# TOWN OF CORTLANDT PLANNING BOARD

**MEETING AGENDA.....PLANNING BOARD  
TOWN OF CORTLANDT  
6:30 THURSDAY EVENING\*  
OCTOBER 7, 2025**

**PB 2023-5** a. Letter dated September 29, 2025 from David Steinmetz, Esq. requesting the 7<sup>th</sup>, 90-day time extension of Final Plat Approval for the Evergreen Subdivision located at 2003 Crompond Road.

DRAWN BY: RCC  
PROJECT NO.: 812  
DATE: 11/30/23  
DRAWING NO.: SP-2.2

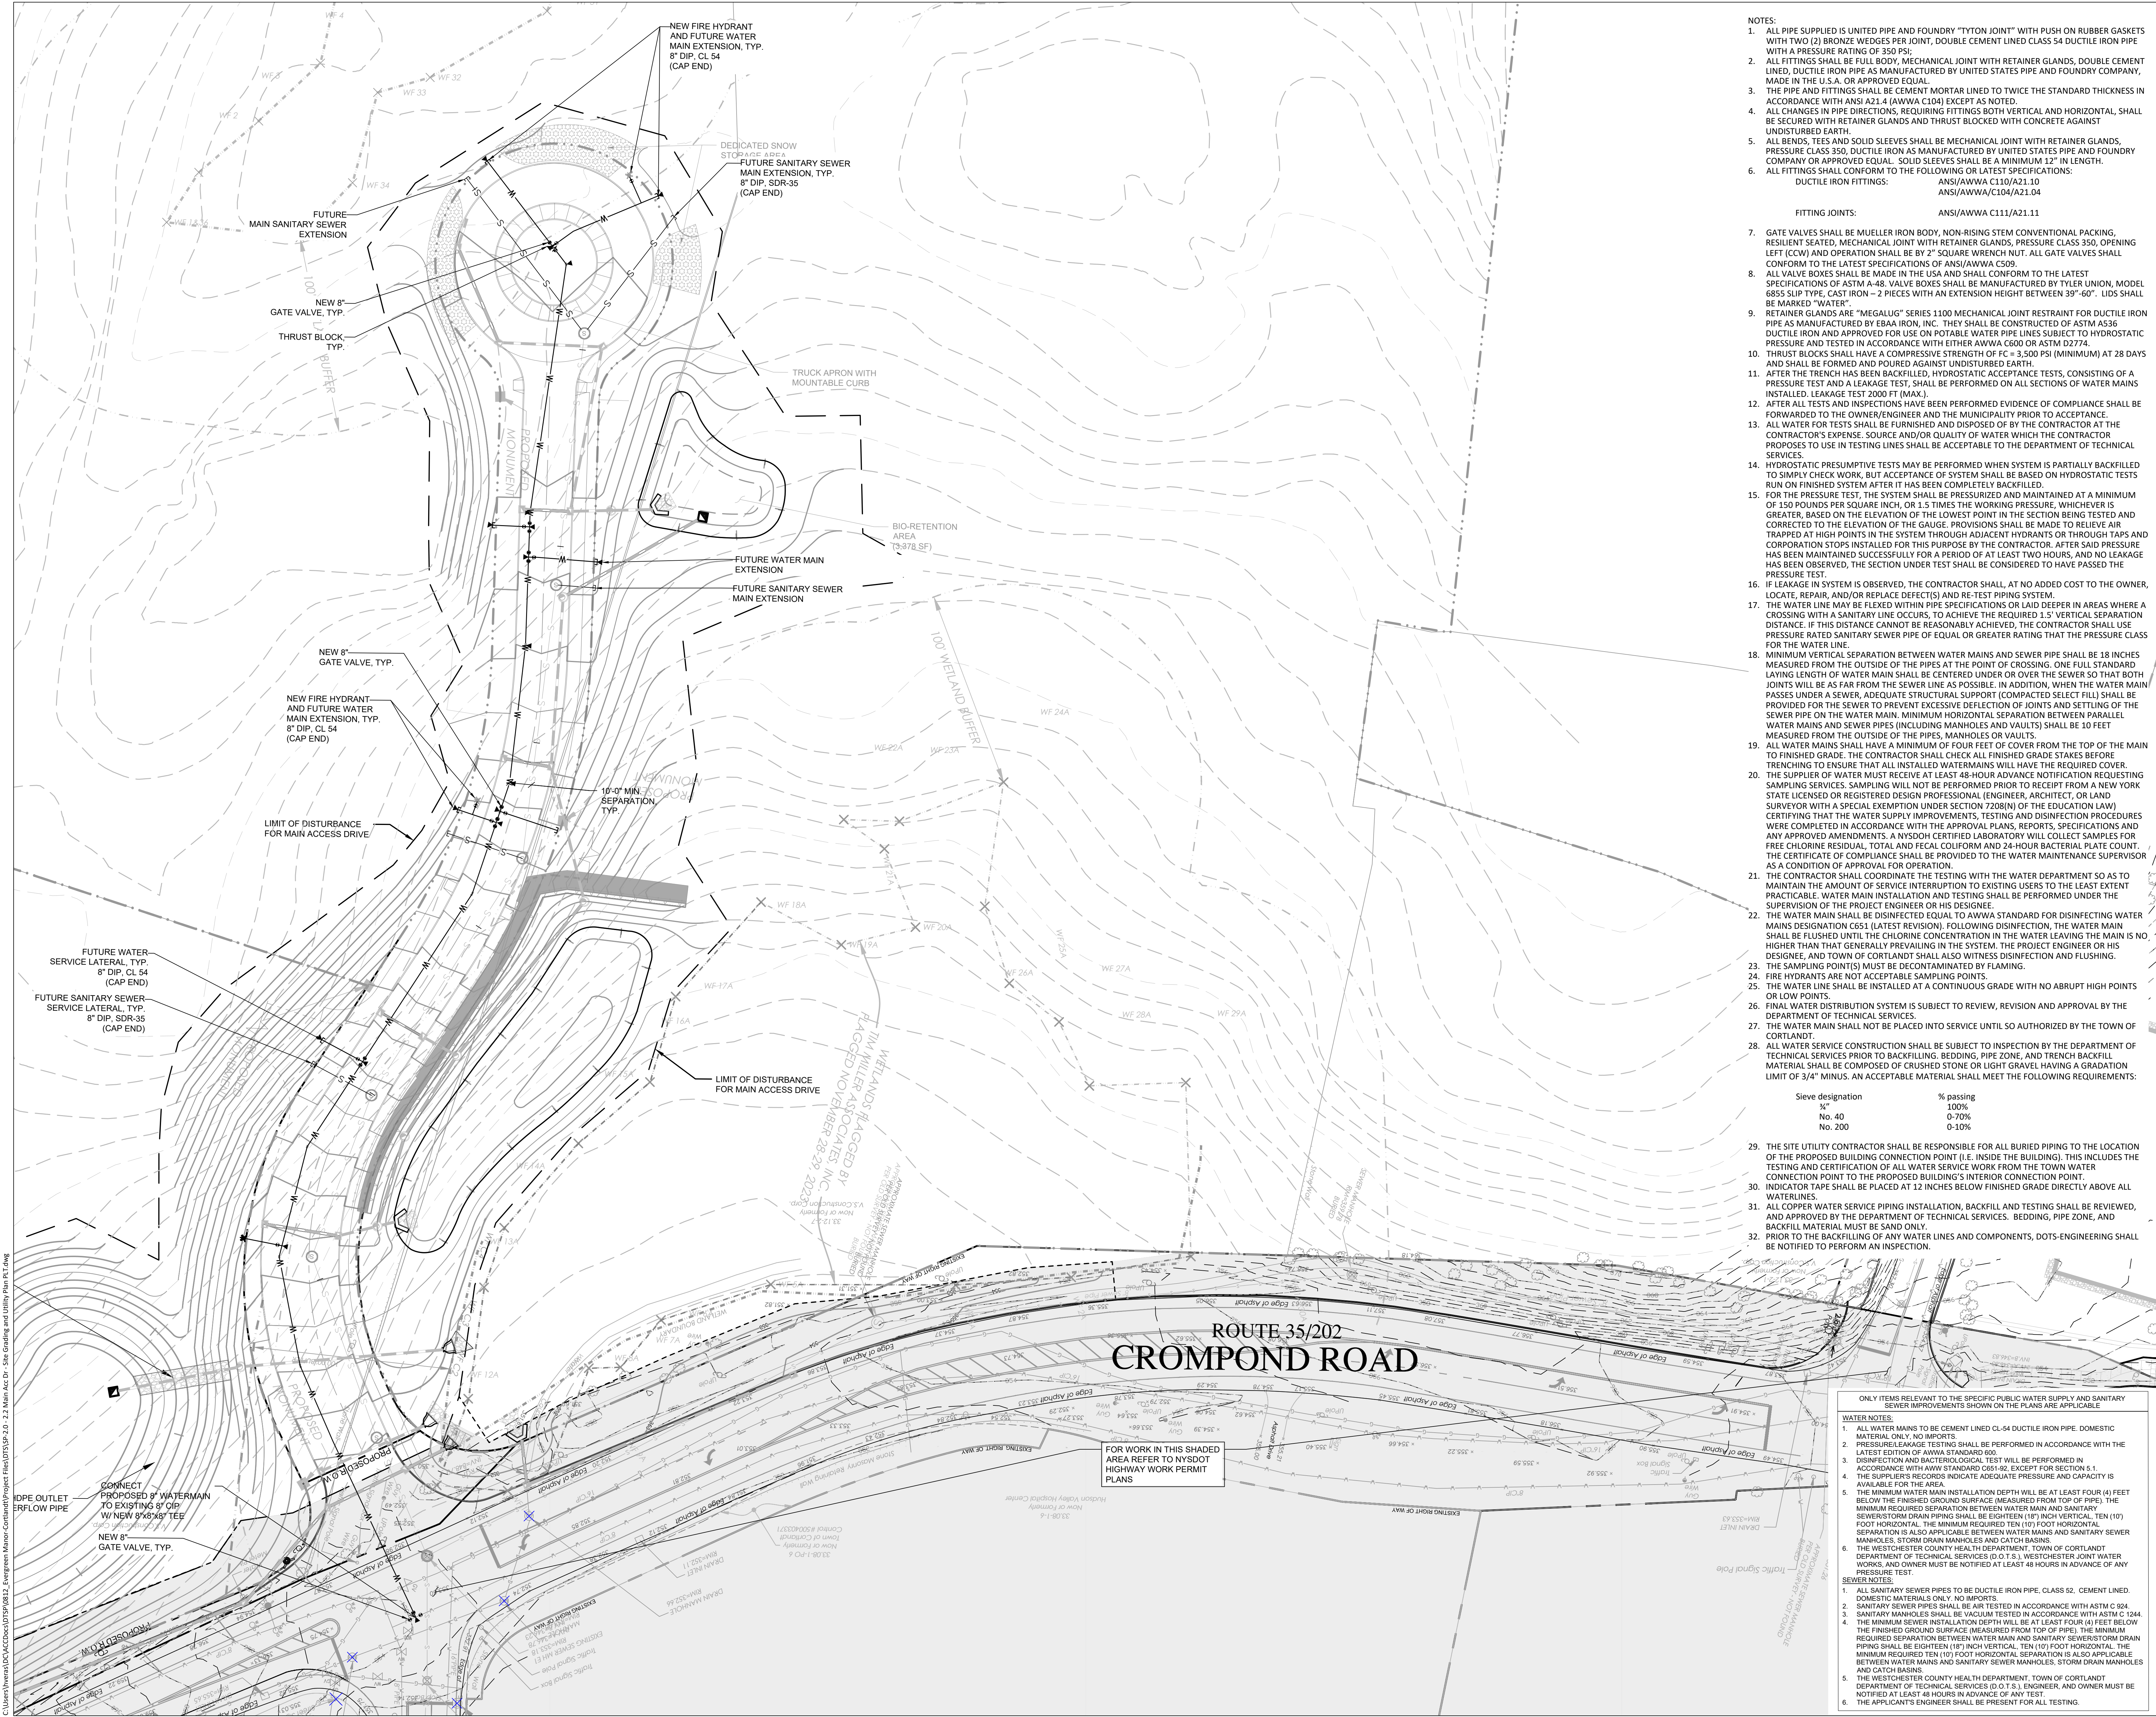
38. **Comment:** *SP-2.2 – The proposed water stub does not match the water connection shown for the Lot 1 development plan, dated January 23, 2025. Please rectify.*

39. **Comment:** *SP-2.2 – Include DOTS as part of notification for Water Note 5.*

40. **Comment:** *SP-2.2 – Turn on stationing of water line.*

41. **Comment:** *SP-2.2 - Provide separate connections for the domestic and fire services for the future lots.*

42. **Comment:** *SP-2.2 – Ensure hydrant along loop connecting to Lafayette Avenue is located along a low point for blow off purposes.*

43. **Comment:** *SP-2.2 – Provide separate connection to the water main for hydrants as opposed to stubbing off service laterals.*

44.     *Comment:*         *SP2.2 – Turn on proposed grading.*  
          *Response:*       The proposed grading is now shown on the plan.
45.     *Comment:*         *SP2.2 – Show drainage in gray scale, similar to sanitary sewer.*  
          *Response:*       Drainage is now shown in gray scale on the drawing.

47.     *Comment:*         *SP-2.2 - Add the following notes:*  
                              *a) All pipe supplied is United Pipe and Foundry “Tyton Joint” with...*  
                              *[Bullets b-ee]*  
                              *ff) ... DOTS-Engineering shall be notified to perform an inspection.*  
          *Response:*       The requested notes have been added to the drawing.

48.     *Comment:*         *SP-2.2 – Based upon the on-site soils investigation conducted indicate where*  
                              *additional corrosion protection of the water main will be required.*  
          *Response:*       This will be reviewed with the project’s geotechnical engineer and addressed  
prior to the submission of plans for Building Permit.
